REBUTTAL TESTIMONY OF RON MILLIGAN

Citations of Protestant Testimony to be Rebutted

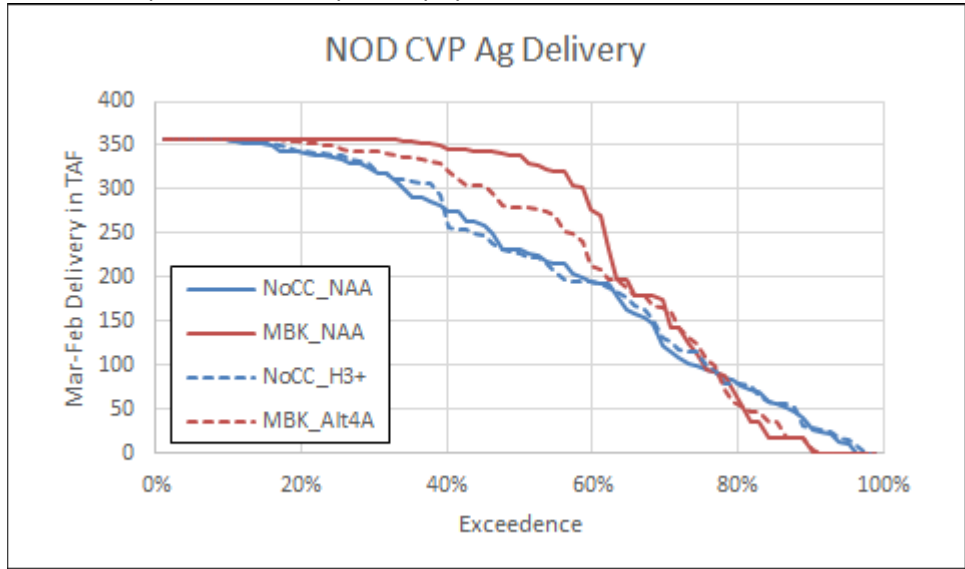
Figure 1.1 – The steep drop in MBK NAA CVP NOD Ag delivery at around the 60% exceedance mark and the very low delivery levels above 80% indicate an extreme distribution of allocations that CVO does not consider reasonable. Reclamation will make more conservative allocations in all but the wettest years in an effort to reserve water supply for more reliable delivery through drought periods. The flatter blue lines in this plot reflect this philosophy.

Figure 1.3a – No Action Alternative Results

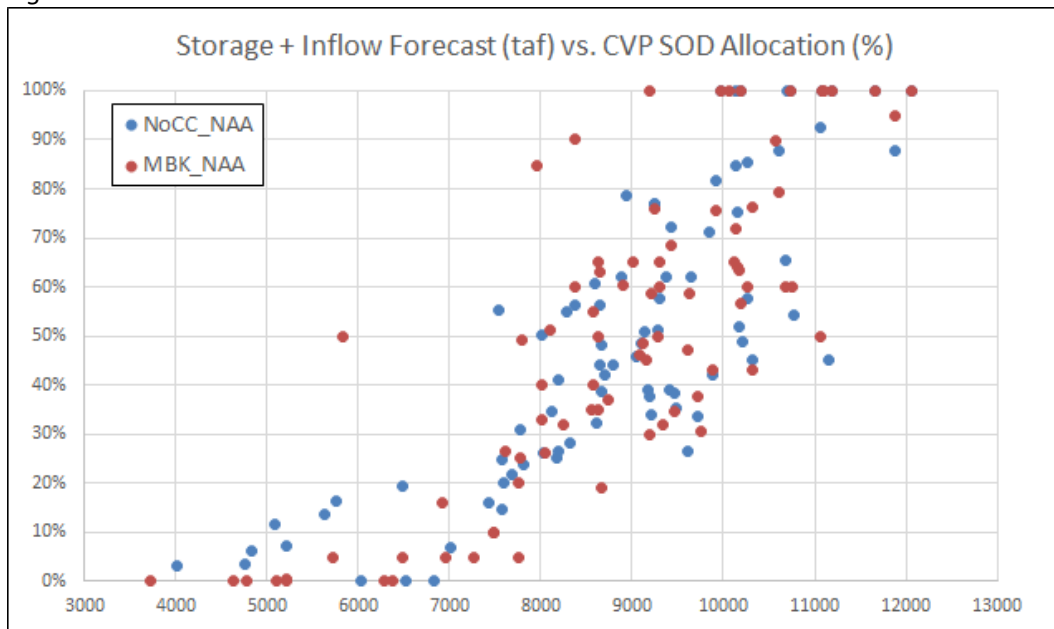
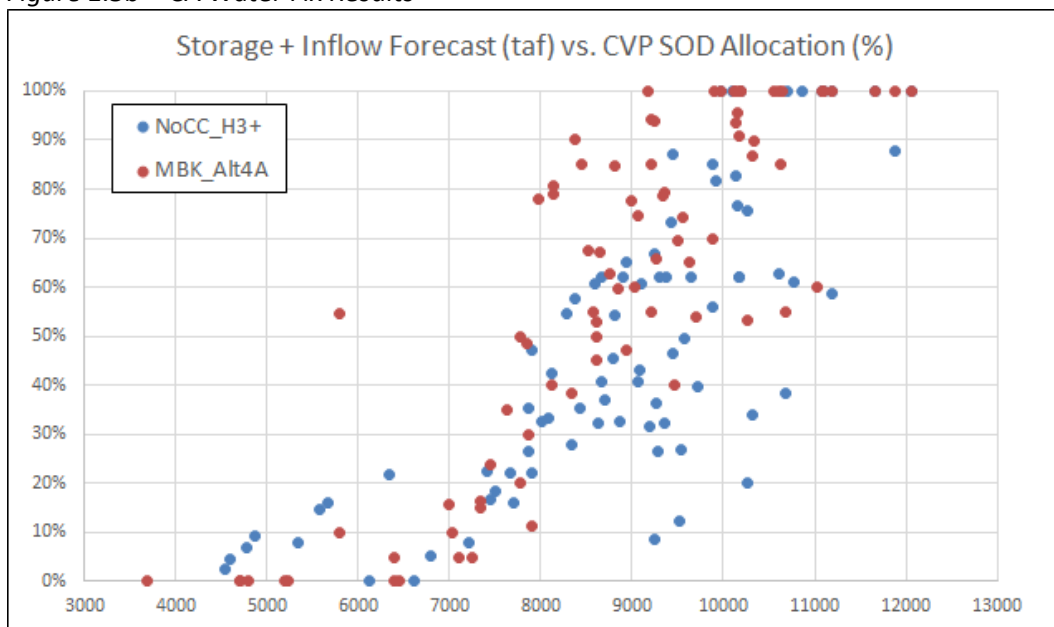
Figures 1.3a and 1.3b offer additional perspectives on CVO and MBK’s allocation decisions. These two scatter plots show final CVP SOD Allocation as a function of the system wide May 1 CVP storage condition and inflow forecasts. Both plots show that Petitioner modeling (blue dots) achieves at least limited delivery even under most of the driest conditions, and somewhat conservative allocations in wetter years when the system is recovering from past dry conditions or hedging against future need for stored water. Conversely, MBK modeling has numerous zero allocations in both studies and pushes WaterFix allocations aggressively in wetter years.

Figure 1.4

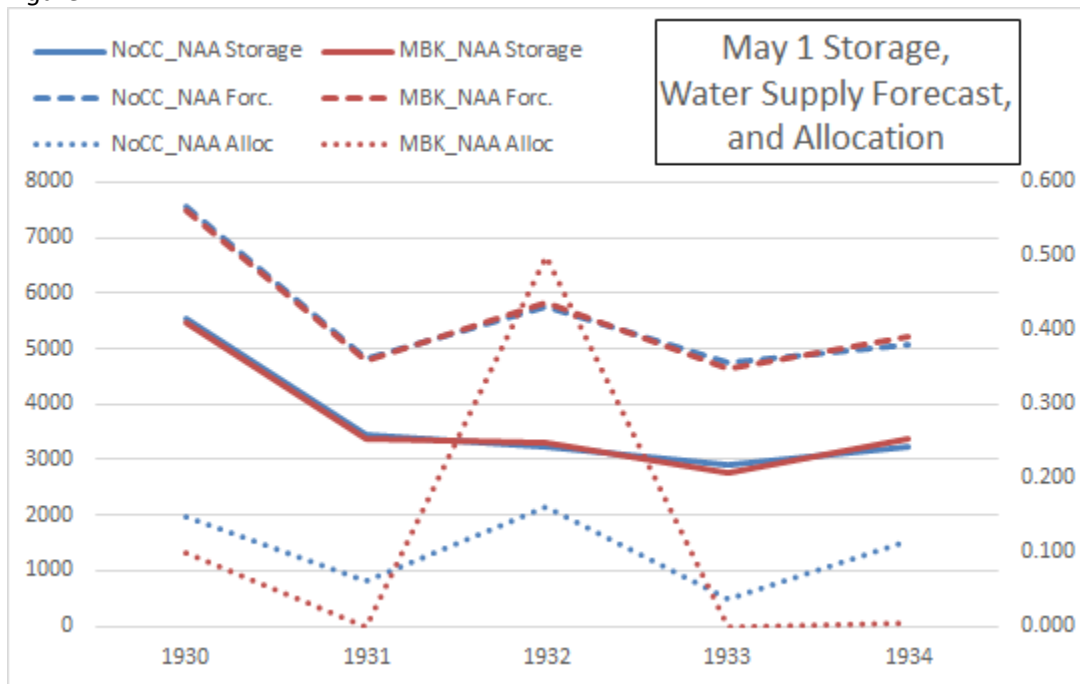
Finally, a look at the sequence of 1931-1933 provides a good example of similar water supply conditions yielding inconsistent allocations in MBK modeling relative to Petitioners' modeling. Figure 1.4 illustrates that MBK's allocation has a jump in 1932 that is out of proportion to the slightly improved water supply forecast relative to the other years. This does not depict a consistent approach to allocation decisions. MBK was able to achieve this operation due to conditions that could not have been foreseen on May 1st through use of the iteratively trained export estimate time series.

Figure 2.1a

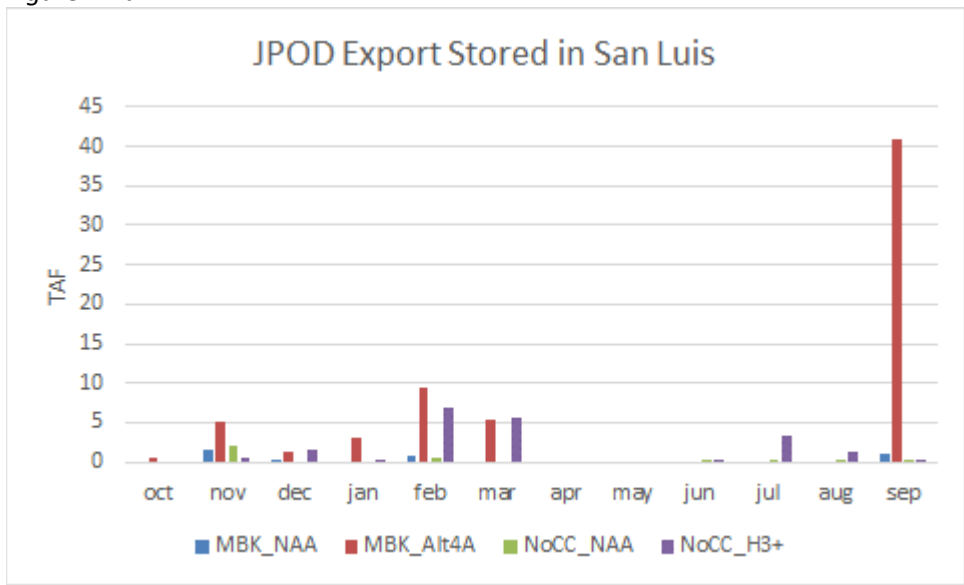
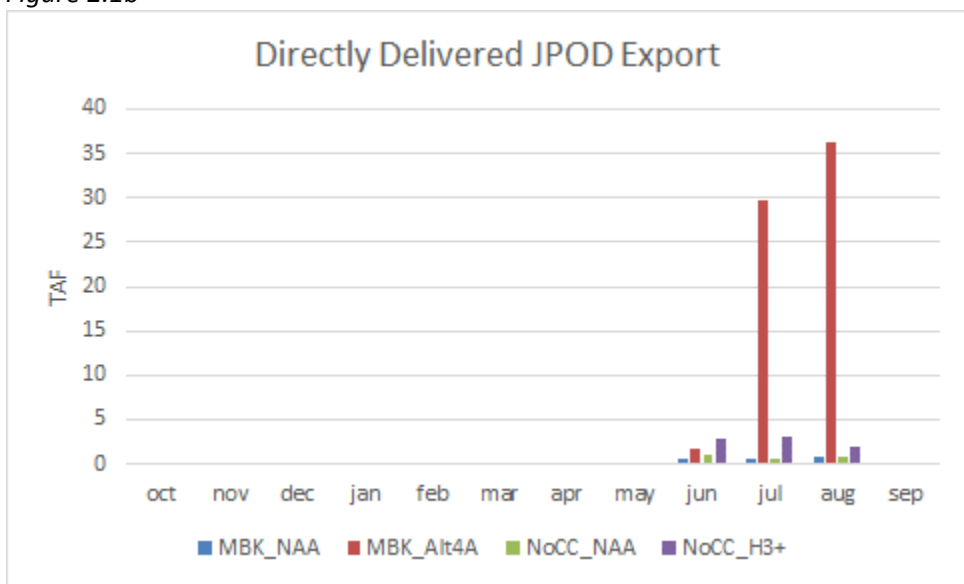
The plots in Figures 2.1a and 2.1b below show the extent to which MBK’s water fix scenario relies on JPOD to achieve the operation they depict as more accurate. For an average increased Ag delivery of 185 taf/yr, 127 taf of that is increased JPOD export at Banks, of which 68 taf is direct delivery in July and August, which is not a reliable element of the CVP allocation process.

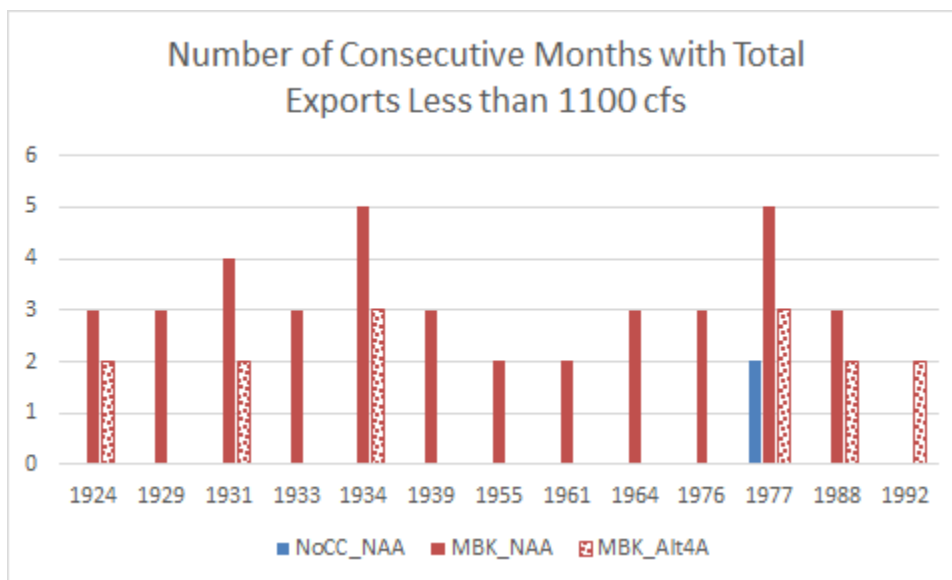
Figure 3.2 – While occasional instances of low exports are acceptable, repeated extended low export conditions are not. There were 12 years in the period of record with sequential months of total exports under 1100 cfs in MBK’s no action alternative, and 6 years in MBK’s water fix alternative. This operation does not comport with the long understanding of minimum health and safety export levels.

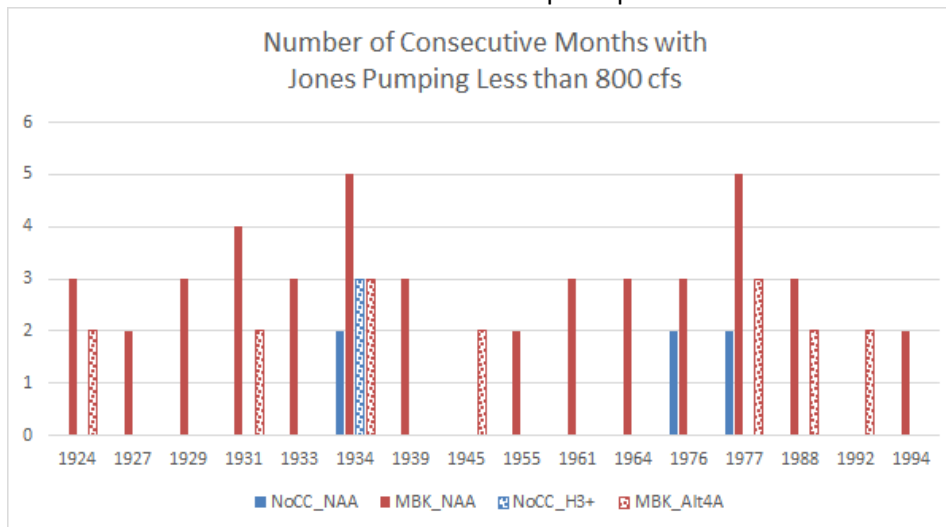
Figure 3.4 – This plot is similar to Figure 3.2, indicating years with multiple sequential months of Jones exports below 800 cfs. Years where successive April/May exports of exactly 750 cfs are not included in this count so as not to conflate the effects of pulse period and B2 constraints with minimum exports.
